Revised Summary of Comments and Responses

Statewide Clean Water Act Section 303(d) List Portion
of the 2020-2022 California Integrated Report

Finalized date:
February 16, 2022

STATE WATER RESOURCES CONTROL BOARD
CALIFORNIA ENVIRONMENTAL PROTECTION AGENCY

Figure 3-1: Maps Showing Relative Reference Influence Measure for CSCI Metrics (six MMI and O/E) at Marsh Creek (Marsh Creek Reservoir to San Joaquin River; partly in Delta Waterways, western portion)

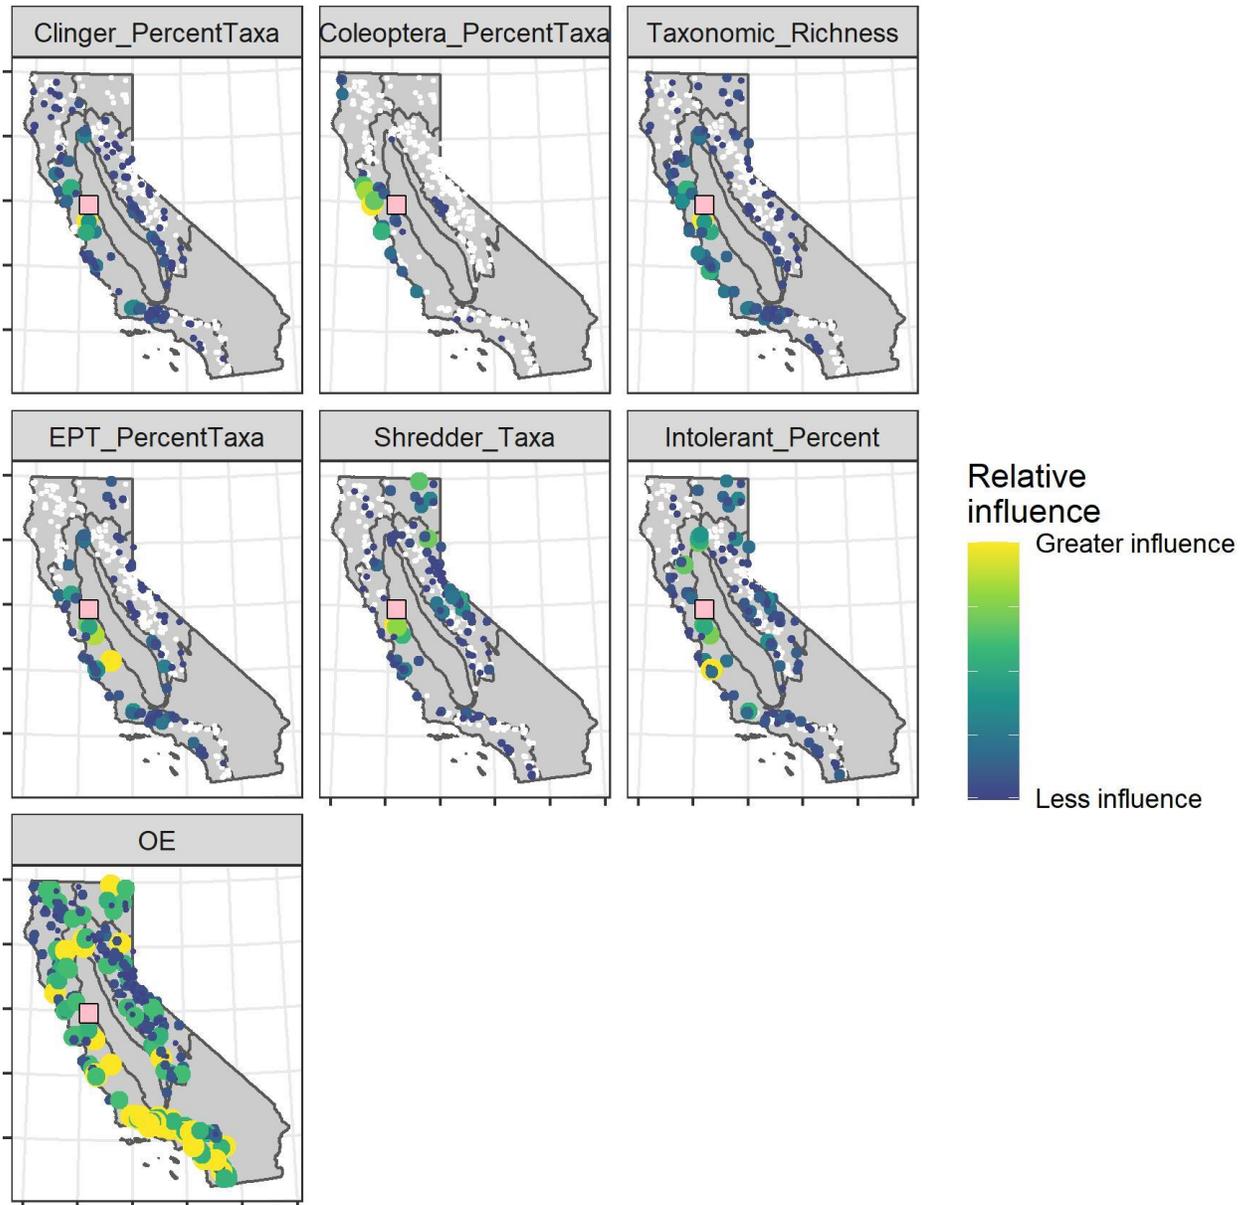
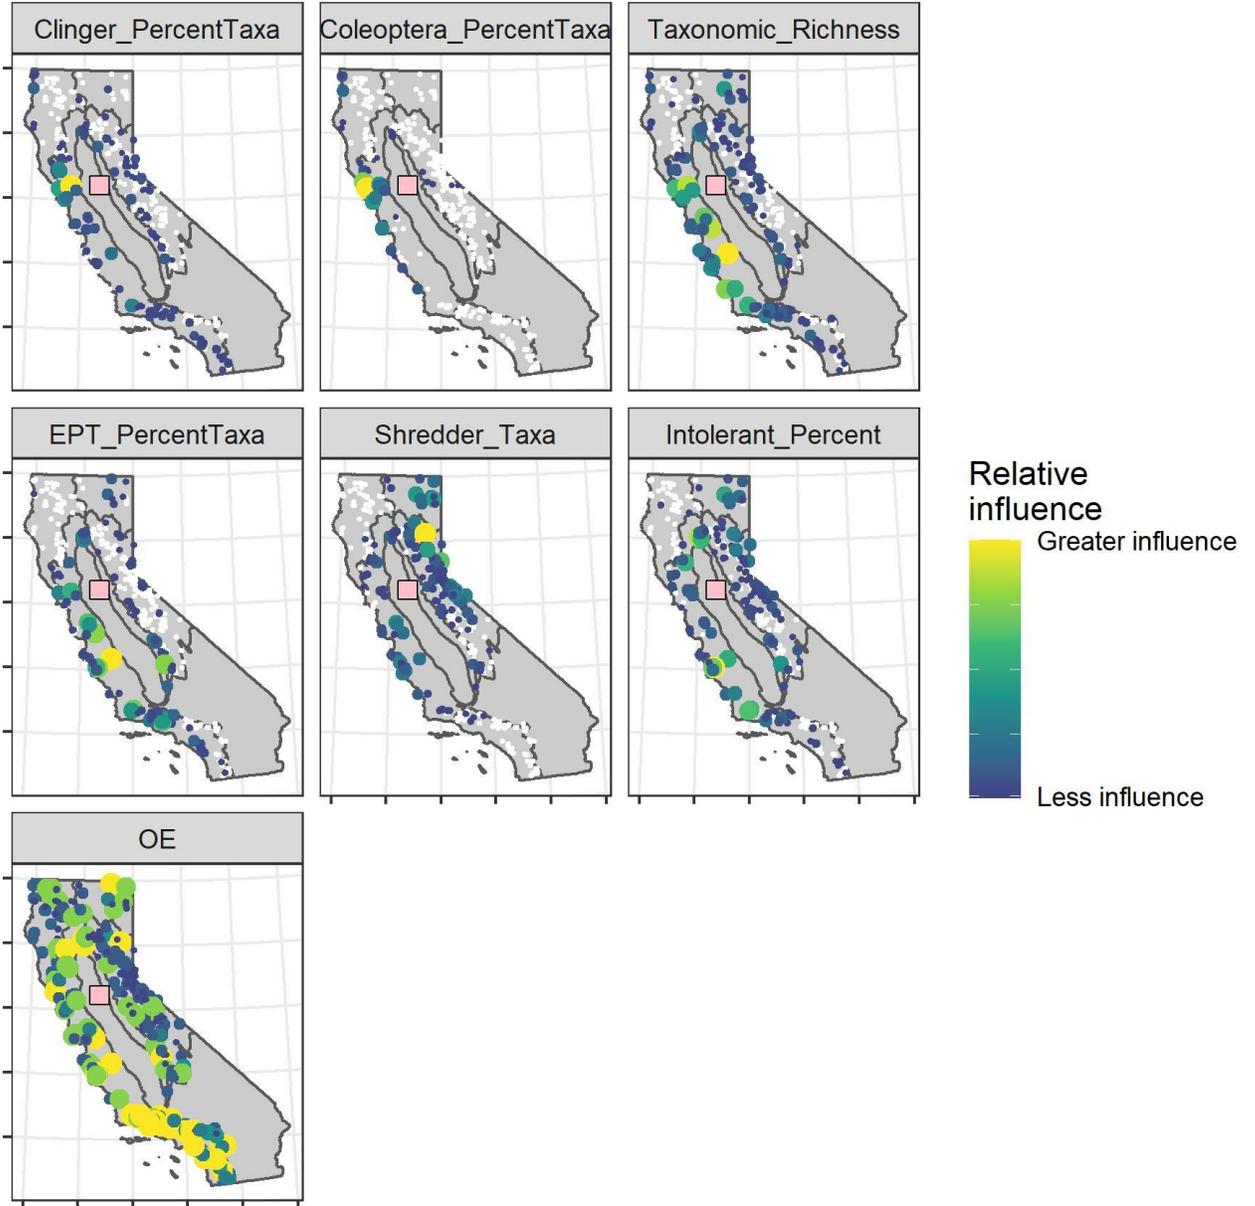
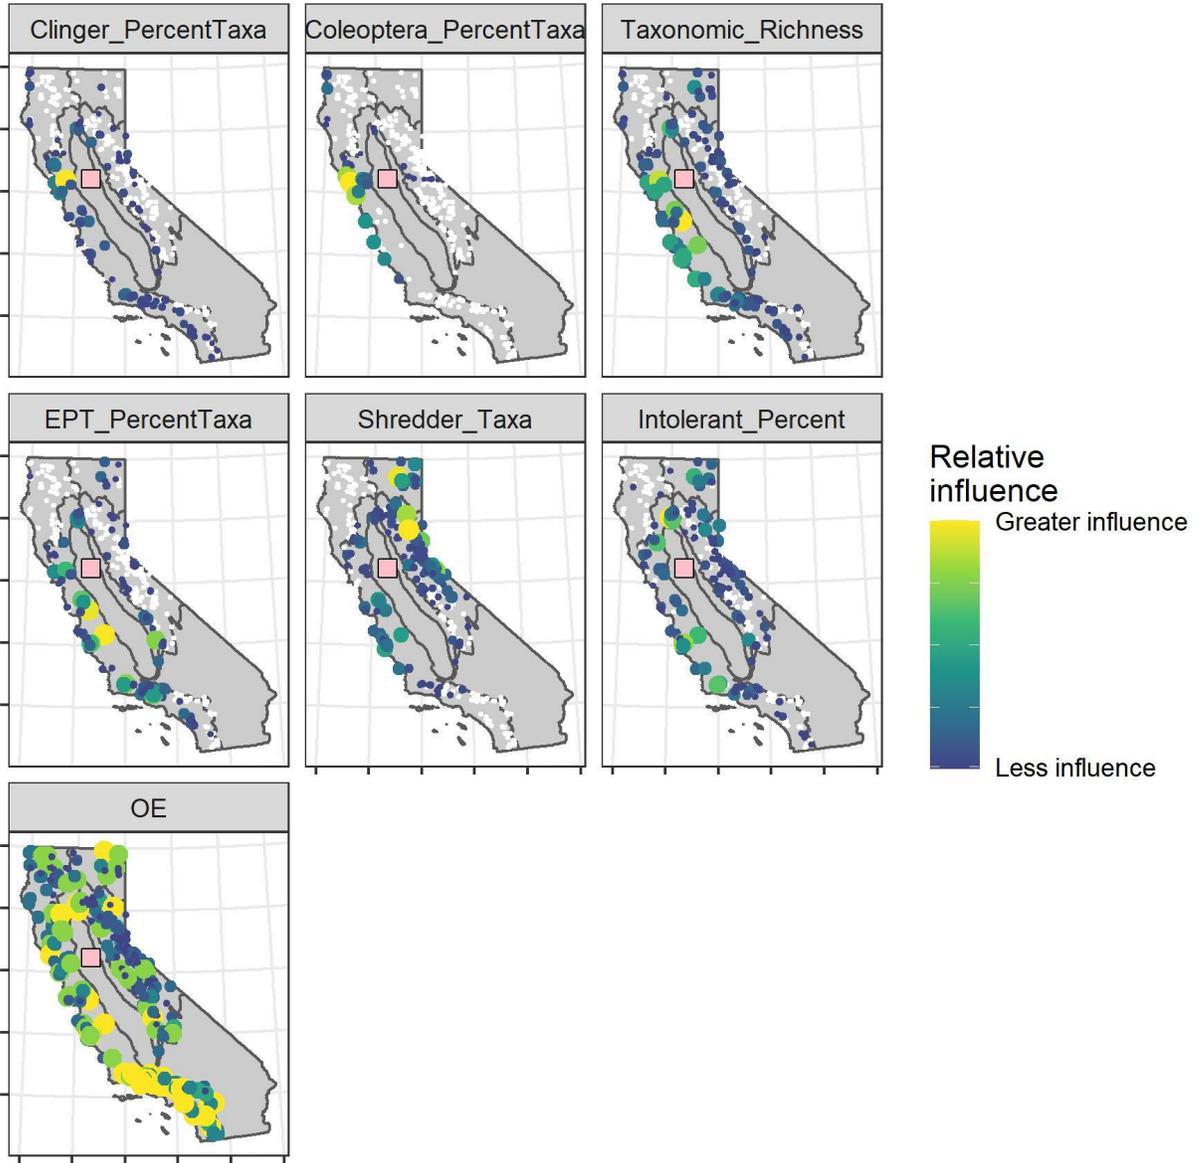
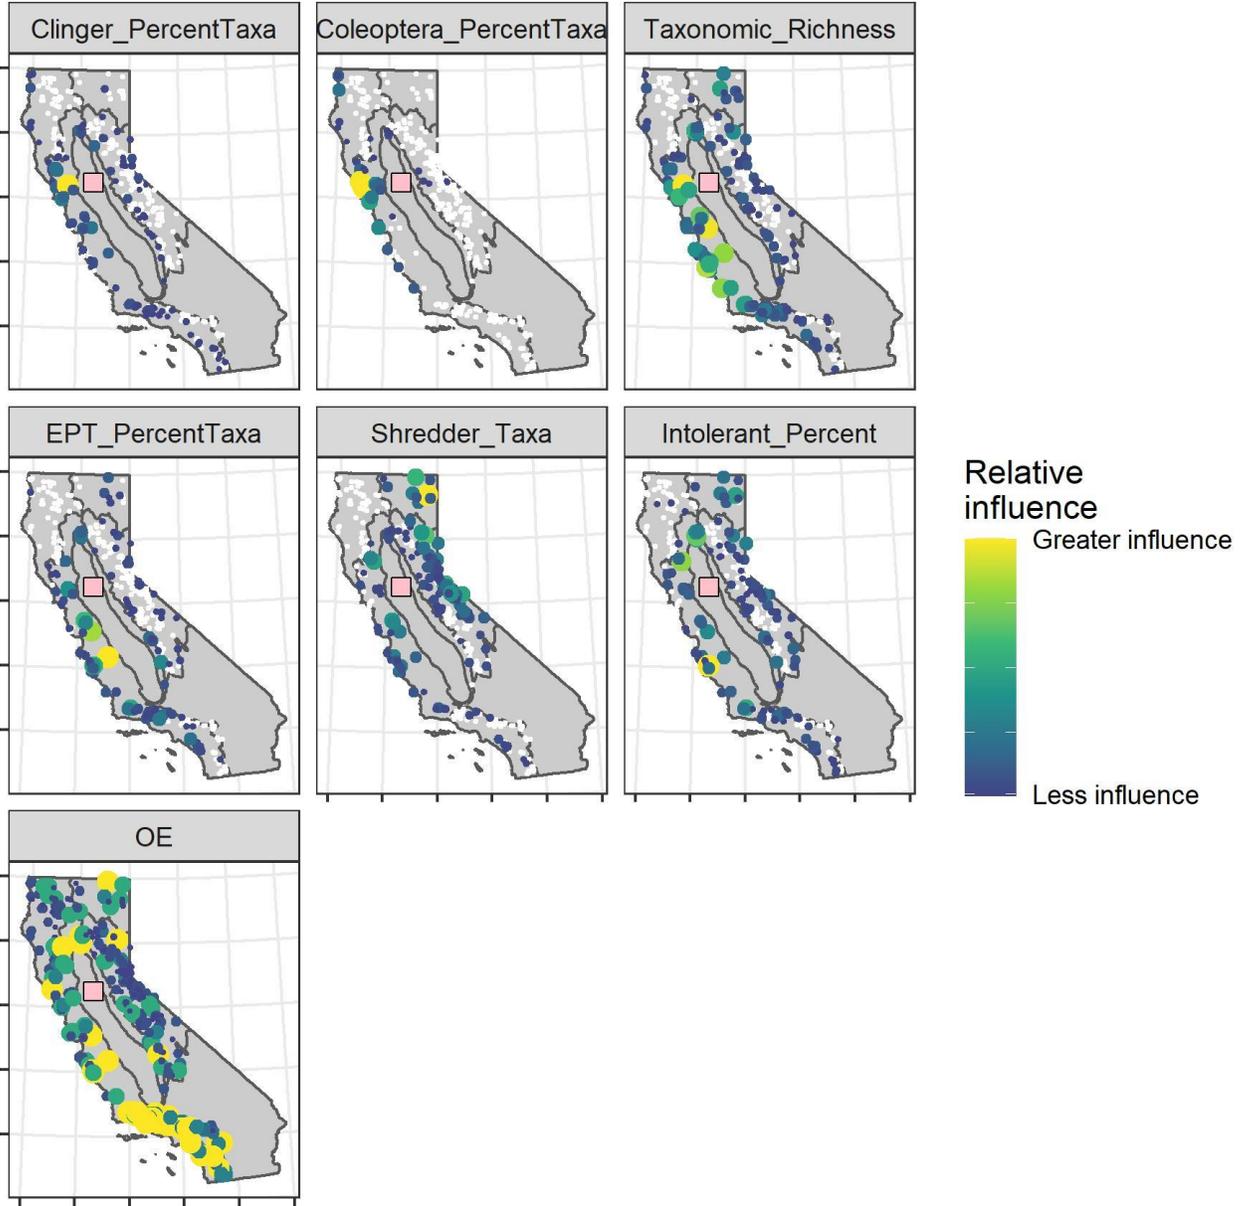
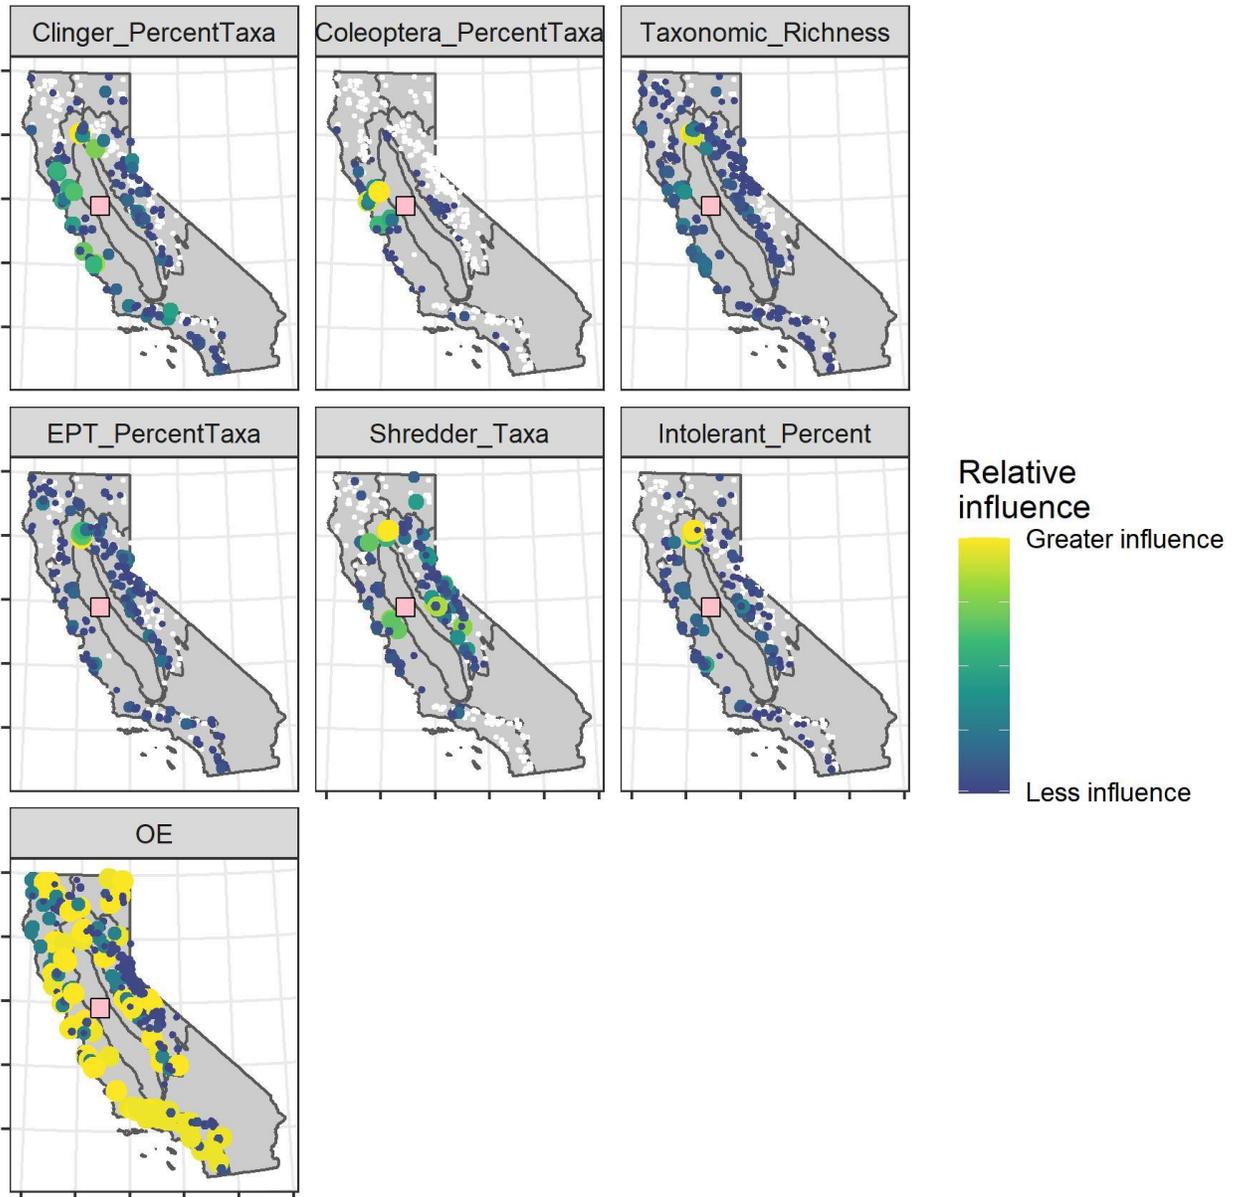
Changes to listing recommendations were not made in response to these comments. Even without a reference site located in the Central Valley floor, use of the CSCI threshold of 0.79 and its pool of reference sites is appropriate for assessing benthic community data for the five Central Valley floor waterbodies for the following reasons.

The weight for O/E and the proximity for the six MMI metrics were then synthesized and mapped. The following series of graphics (Figure 3-1 through Figure 3-5) show the influence of reference sites throughout California to each of the five Central Valley floor waterbodies in terms of the O/E index and the six MMI metrics that compose the CSCI score.
